CITY OF FORT LAUDERDALE

CASE COMMENT REPORT

CASE NO. UDP-S24055

CASE	UDP-S24055
PROJECT NAME	Calvary West Campus
APPLICATION TYPE	Site Plan Level III Review - Conditional Use for School Use over 10,000 Square-Feet in Community Facilities-House of Worship/School District
APPROVAL LEVEL	Planning and Zoning Board with 30-day City Commission Call-up
REQUEST	New 54,710 Square-Foot School Building and a 26,257 Square-Foot Theater Building with Associated Site Improvements and Parking
APPLICANT	Calvary Chapel of Ft Lauderdale, Inc.
AGENT	Emilio McLean, Calvary Christian Academy Construction Manager
PROPERTY ADDRESS	6330 NW 31st Avenue
ABBREVIATED LEGAL DESCRIPTION	8-49-42 Acreage
ZONING DISTRICT	Community Facility/House of Worship and School (CH-HS)
LAND USE	Community Facility
COMMISSION DISTRICT	1 – John Herbst
NEIGHBORHOOD ASSOCIATION	N/A
SUBMITTED	August 27, 2024
COMPLETENESS ISSUED	February 25, 2025
EXPIRATION	August 25, 2025 (180 Days)
WAIVER	Not Requested
CASE PLANNER	Tyler LaForme, AICP Urban Planner III

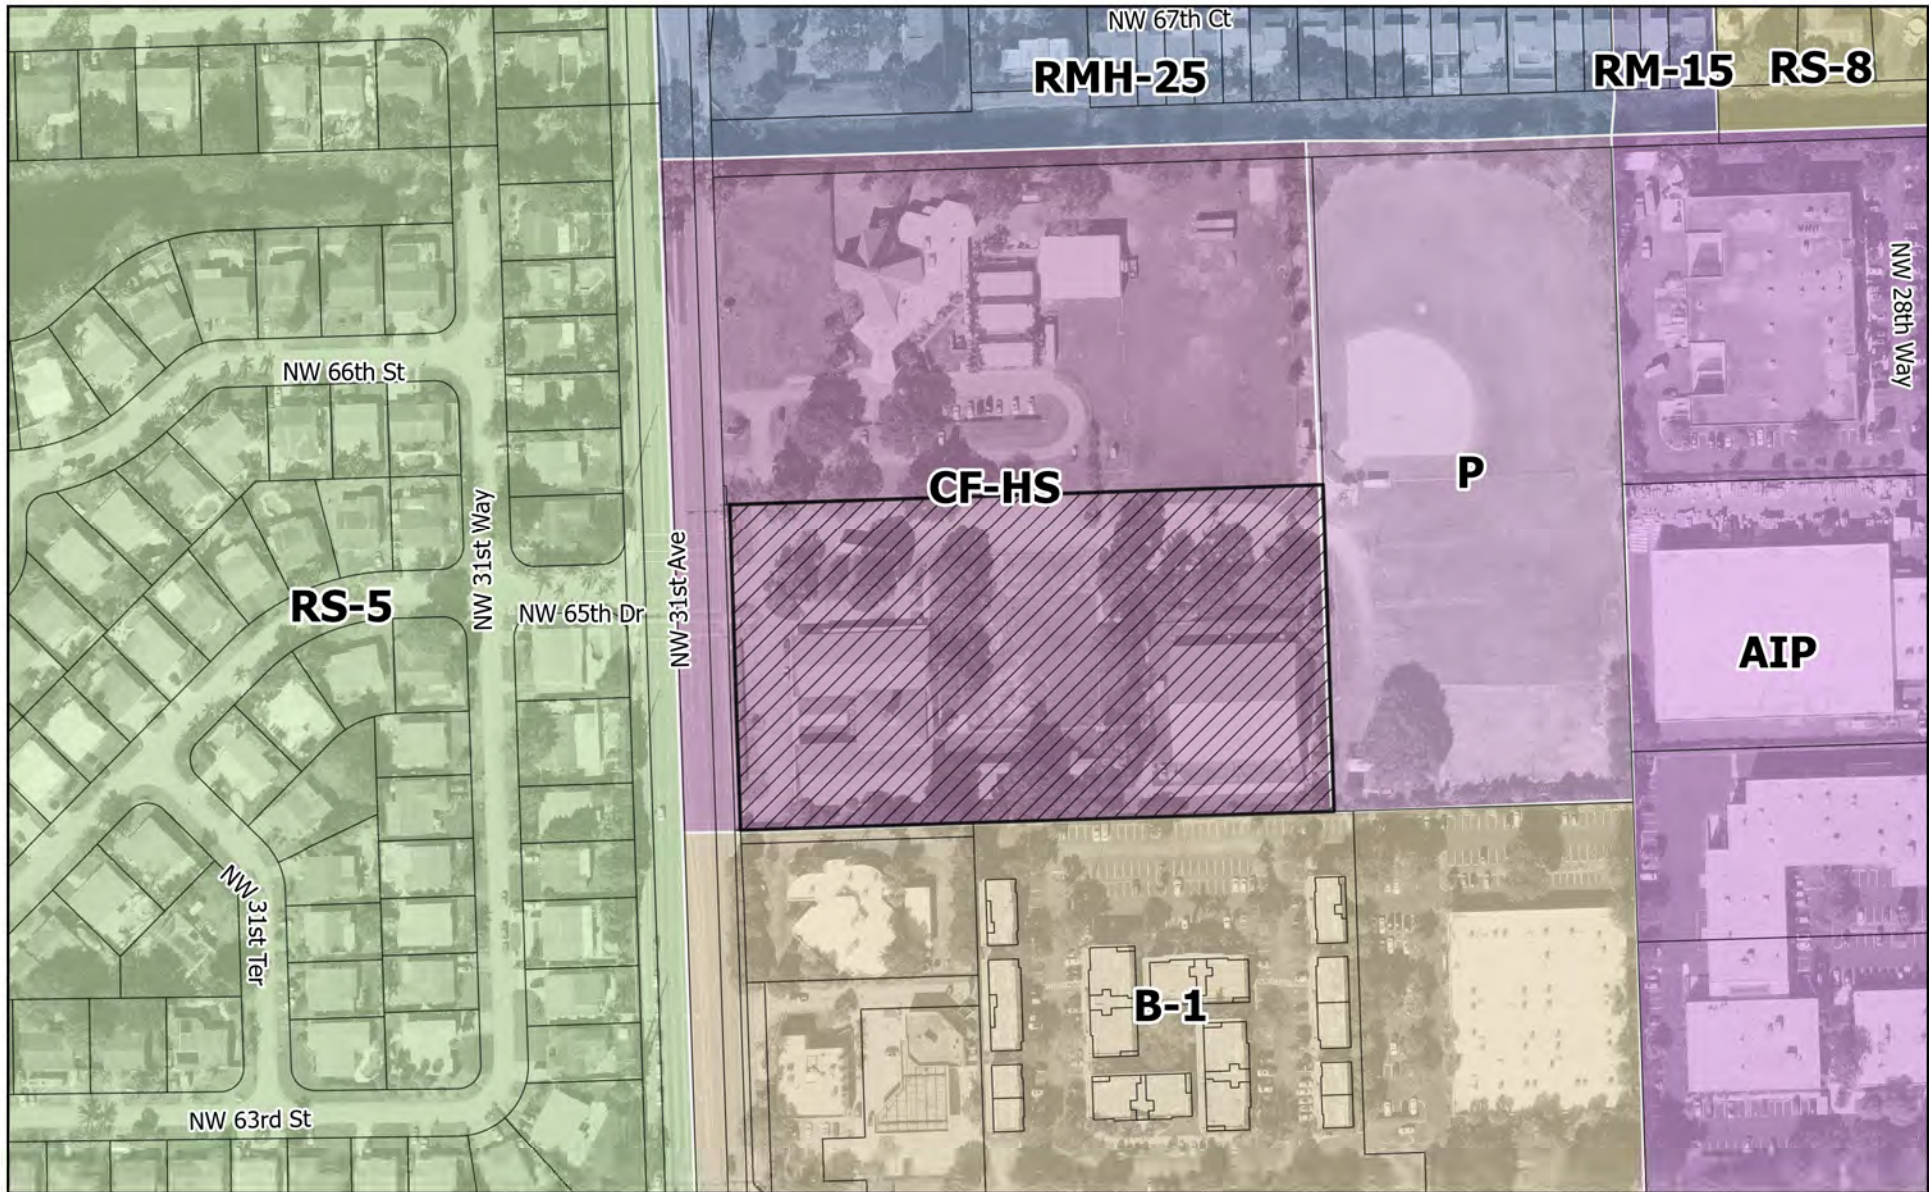
- 6) Provide the following changes on the site plan:
 - a. Shift the large label that indicates the zoning district off of the plan itself. It is covering a portion of the parking lot and circulation. Some of the labels on the zoomed in plans are covering aspects of the

- plans. Ensure that those labels do not cover the lines on the plans as it is hard to see what is going in those locations.
- b. Update parking data table on the site plan to clearly identify the uses, required and proposed, existing parking, etc.
